District of Columbia Government Advisory Neighborhood Commission 6A Box 75115 Washington, DC 20013

Re: ANC 6A Rank-ordered preference for 1300 North Carolina Ave NE Concept Designs

Alternative C – One-Way + Buffered Bike Lane

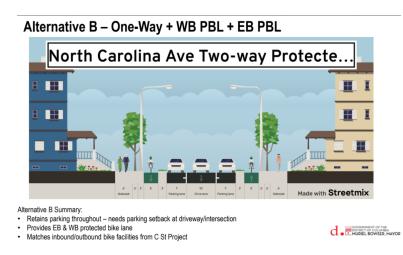
Option C. One Way with Buffered Bike lanes in each Direction. If B or E are unable to be selected, Option C is our third preferred option. As we have seen on nearby streets such as 14th St and 17th St NE,

traditional paint-only bike lanes that are not physically separated by vehicles, planters or concrete delineators encourage speeding by drivers as the visual space is larger and they are able to drift into the bike lane space and increase their speeds--and in some cases use the bike lane as a passing lane. While the buffered bike lanes provides greater protection than a standard bike lane, in lacking any separation other than paint, this design also risks driver and

cyclist conflict and persistent illegal standing, stopping or parking in the bike lane. While this option is preferable to the rejected A and D options, we would select this option only if Options B or E were not allowable/feasible. Traffic calming is even more essential for this option.
